**RE: Shoppes at Ellison (S. of La-Z-Boy)
Drainage and Grading Plan | Engineer's Stamp Date 5-23-2016 (File: A14D010E)**

DRAINAGE AND TRANSPORTATION INFORMATION SHEET (REV 09/2015)

RE: Shoppes at Ellison (S. of La-Z-Boy)
Drainage and Grading Plans, Revised 05/23/2016 (File: A14/D010E)

C1.1

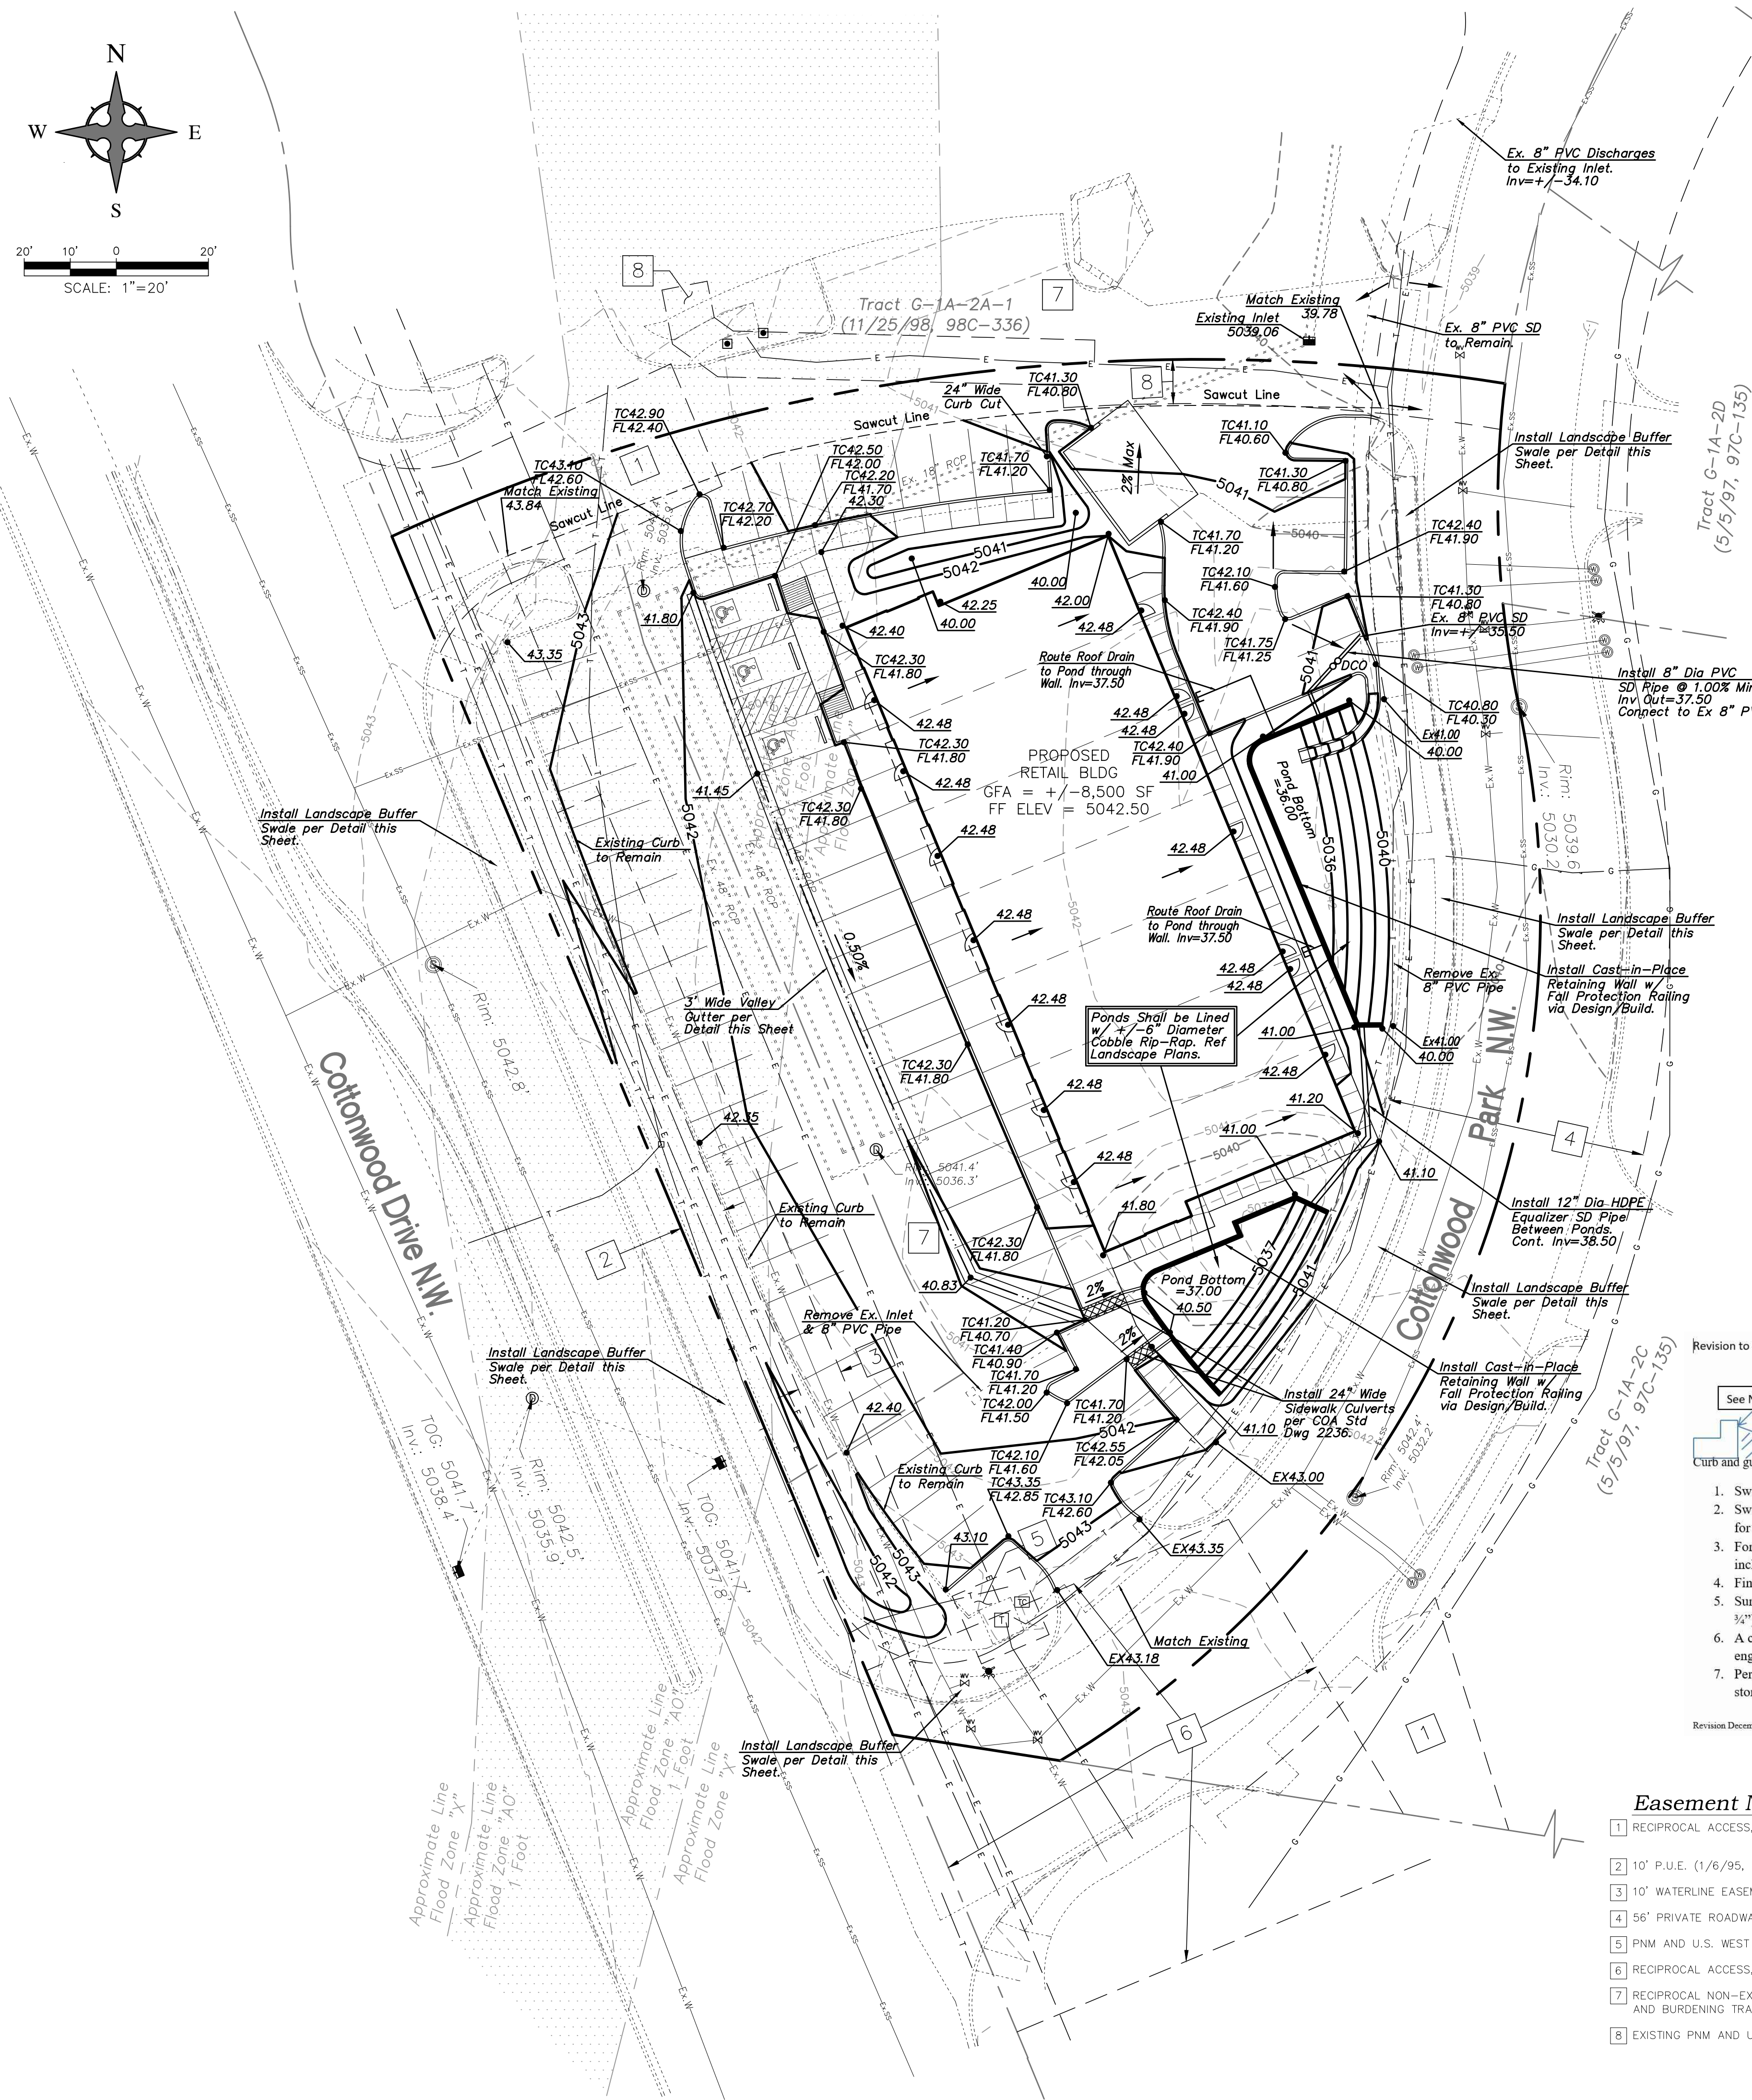
1. Since the 12" pipe is an equalizing pipe, there is a single invert elevation of 5038.50 as shown on the note for the pipe on the grading plan.

2. The ponds have been sized to capture over the 100-Yr, 6-Hr storm; therefore, the ponds are sized adequate to prevent overtopping. The 8" pipe is only being installed to allow the pond to discharge quicker than just evaporation and infiltration alone. If you prefer, we can delete the proposed 8" pipe and allow any excess flows to discharge over the parkway/curb into Cottonwood Park.

5. A set of double cleanouts have been shown on the proposed 8" pipe. The section of existing 8" pipe to remain already has double clean-outs installed per the original plans by RP Bohannon.

6. The proposed roof drains have shown and flow arrows added to the grading plan showing direction of flow. All roof drains shall drain into Pond 'C'.
7. We have added elevations on the first flush calculations table as required for Ponds 'B' and 'C'. Since the ponds are in a 'retention' condition, all flows are captured.

Landscape Buffer Swale Detail

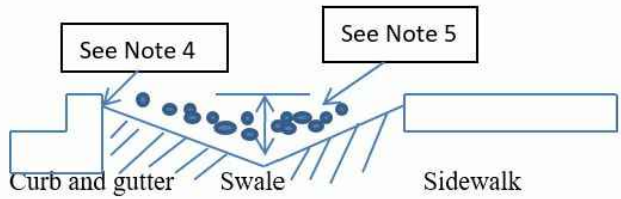
3. We have added the 'Landscape Buffer Swale' detail you sent over and added notes as required.
4. We have added a detail for the Sidewalk Culvert/Wall detail as requested.

Revision to City Standard Drawing 2405A and 2405B to include Landscape Buffer Swale.

- Swale to be 6" deep when the distance between back of curb and the sidewalk is 5 feet.
- Swale to be 1" deeper than the distance in feet between the back of curb and the sidewalk for landscape buffers different than 5 feet wide.
- For extremely wide landscape buffers, greater than 10 feet, the maximum depth is 10 inches.
- Final grade of dirt to be 1 to 2 inches below top of curb and top of sidewalk grade.
- Surface between back of curb and sidewalk to be covered with gravel mulch (minimum 3/4"), cobbles or rip-rap. Do not fill entire swale.
- A check dam will be required for swales on steeper slopes and longer sections. The engineer will determine the location.
- Permeable landscape fabric is not required, but is acceptable, between the dirt and the stone.
